### **Flooding:**

### **Flood Level in PMF**

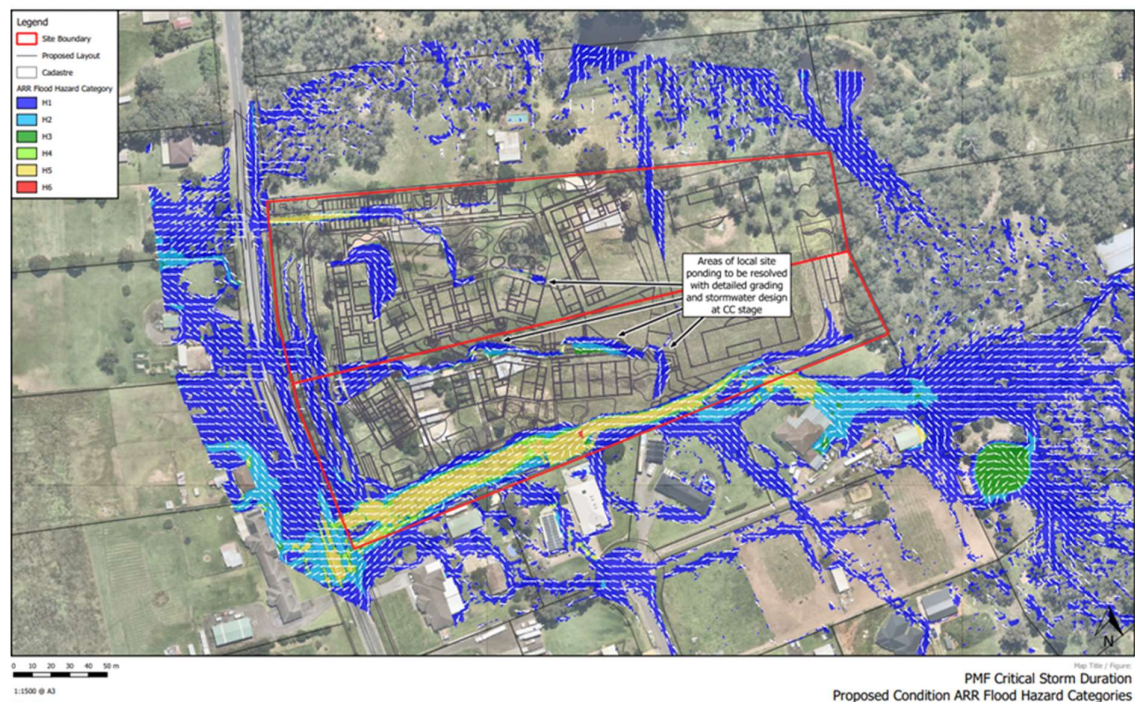
Appendix P fails to discuss the conditions on the site during a PMF event although this is the flood event that has the potential to cause the greatest impact. The images below show the flood risk with the proposed development which shows H5-H6 along the southern boundary.
